# **Wylfa Newydd Development Area**

## Analysis of the Noise and Vibration Assessment of the Site Campus

**Date:** 3<sup>rd</sup> December 2018

**Client Name:** Land & Lakes

Figure 1 Noise Monitoring Plan

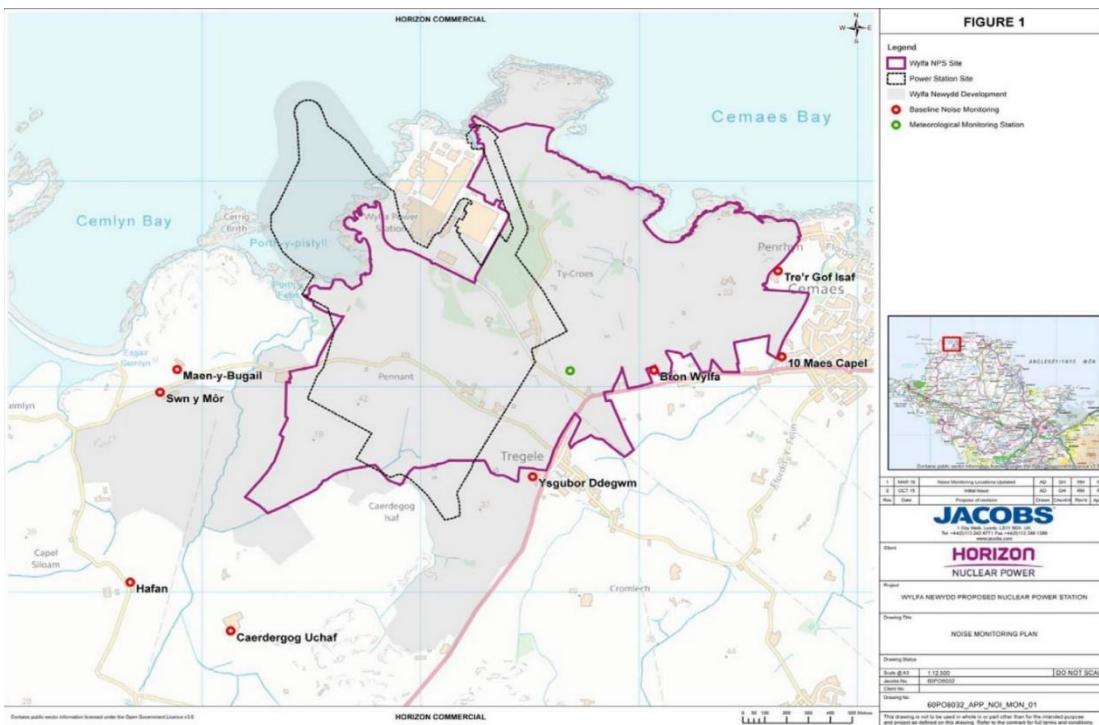
2.4. The locations that were subject to baseline noise survey are as presented in Figure 1 on page 11 of the Baseline Noise Report, which is presented as Figure 1 below for ease of reference. The survey locations are at significantly greater distances from the identified noise sources at Wylfa than the proposed Site Campus and this confirms that baseline survey information was not gathered for the location of the TWA.

2.5. The residential property identified as MP1 Tre'r Gof Isaf, which is also to the east of the transformer at the Existing Power Station, was surveyed for baseline noise but is some 1.25km away. At this location the noise survey notes identified an “audible hum and short alarm from direction of Existing Power Station”; this despite the property being over 1km further away than the proposed Site Campus and with “no line of sight to Existing Power Station”. Again, the Site Campus will be within a few hundred meters of the transformers with direct line of sight.

2.6. Given the proposed use of the Site Campus as a residential institution, and given the evidence showing that properties significantly further away have experienced noise from the Existing Power Station transformers to a degree that complaints have been made, our view is that a more robust assessment of the baseline noise environment at the Site Campus location is required in order to confirm its suitability for the proposed use, regardless of the potential construction related noise.

**Figure 2** Noise Monitoring Plan

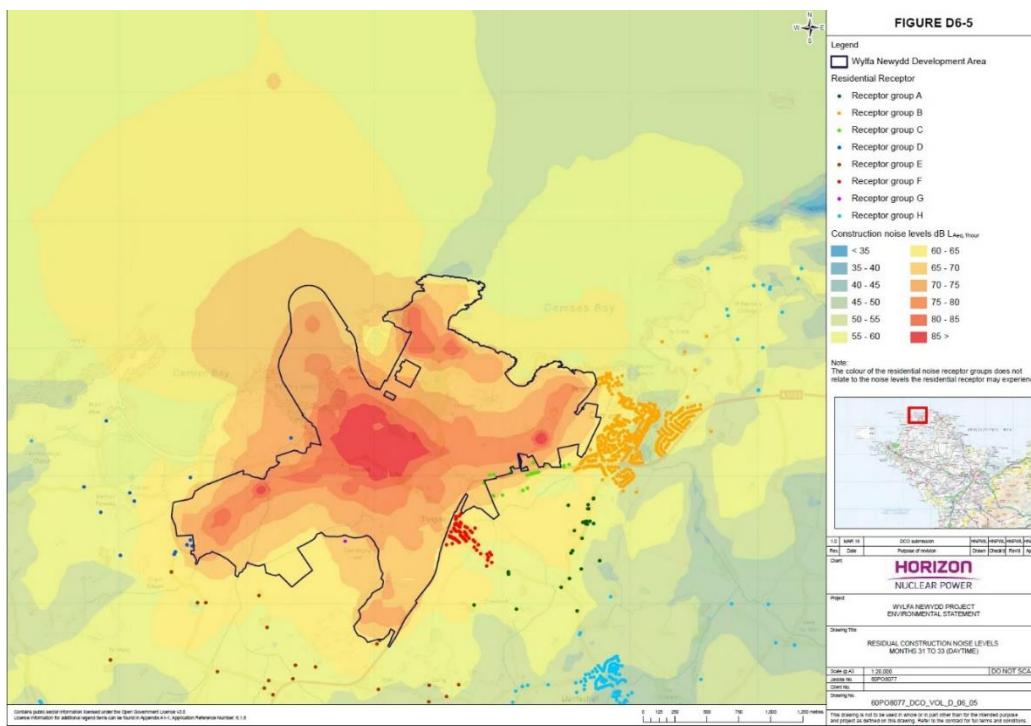
2.10. Figure D6-5, reproduced as Figure 2 below, shows the noise mapping for months 31 to 33, which indicates that the construction noise levels during the daytime at the Site Campus are 70dB – 85dB  $L_{Aeq, 1 hour}$ . Even though this represents noise over a shorter time period than that described above in the ES (quoted above), this is an extremely noisy environment and not obviously compatible with

the objective of providing sleeping accommodation for night shift workers. It is this shorter time period ( $L_{Aeq, 1\text{ hour}}$ ) that is used for the assessment of construction noise for all receptors apart from the Site Campus and which is consistent with the requirements of BS5228-1, the appropriate methodology for this assessment. Further to the above the assessment does not reference the  $L_{Amax,F}$  criteria which is of key importance when considering 'sleep disturbance' and the future amenity of residents.

2.11. It is worth noting that the assessment of the noise impact on residential receptor groups identified large magnitude (major significance) impacts on 22 properties, as shown on Figure D6-5. These were mostly in Receptor Group C (green) and F (red), which are shown as being in a quieter noise zone than that covering the Site Campus. Although this image illustrates the day time scenario, it is worth mentioning again that the Site Campus would have night shift workers sleeping in these conditions during this period of the day.
